DEVELOPMENT APPLICATION ASSESSMENT REPORT

Application Number:	DA2021/0317
----------------------------	-------------

Responsible Officer:	Gareth David
Land to be developed (Address):	Lot 2 DP 833902, 141 Riverview Road AVALON BEACH NSW 2107
Proposed Development:	Construction of a dwelling house
Zoning:	E4 Environmental Living
Development Permissible:	Yes
Existing Use Rights:	No
Consent Authority:	Northern Beaches Council
Delegation Level:	DDP
Land and Environment Court Action:	No
Owner:	Uday Bhaskar Bonu Kavitha Bonu
Applicant:	Key Urban Planning

4.3 Height of buildings

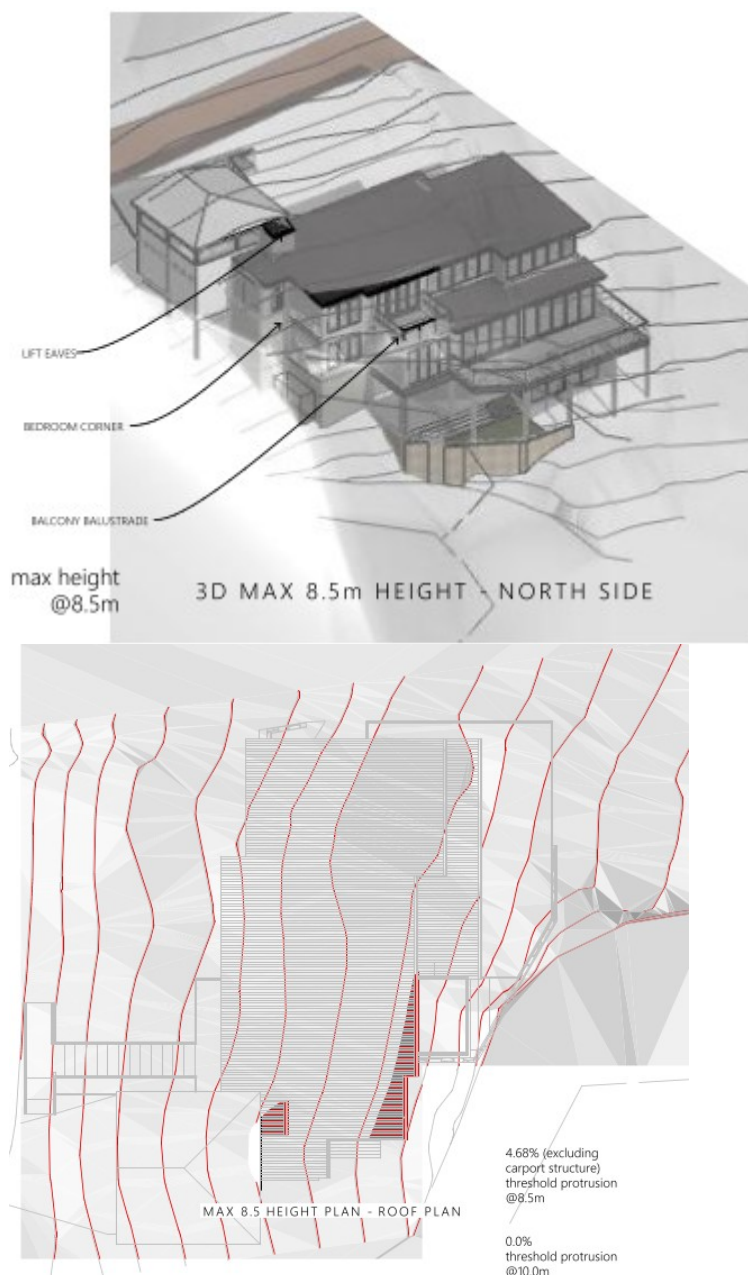
The proposed dwelling has a maximum building height of 8.9 m which does not comply with the 8.5m requirement.

The variation to the 8.5m height limit is not excessive and is demonstrated in Figure 1 bellow. As shown the extent of the variation is predominantly limited to the roof form.

Figure 1 - Proposed building envelope non-compliance on the northern elevation (highlighted in green).

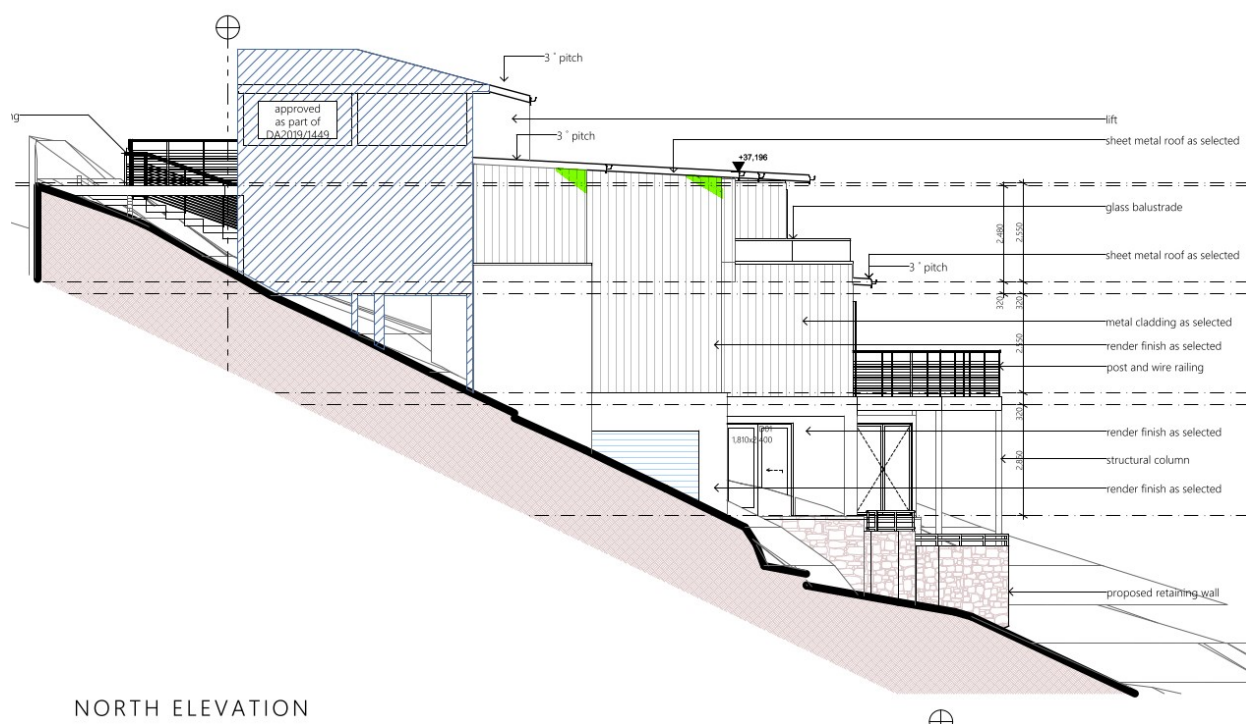
The proposed dwelling has a minor encroachment into the prescribed building envelope along the northern and southern elevations. This variation is represented in figure 1 and 2 below.

This building envelope non-compliance is largely attributed to the slope of the site, which exceeds 30%. P21DCP allows for a variation to the prescribed building envelope for development on steep sites, subject to consistency with the outcomes of this Clause.
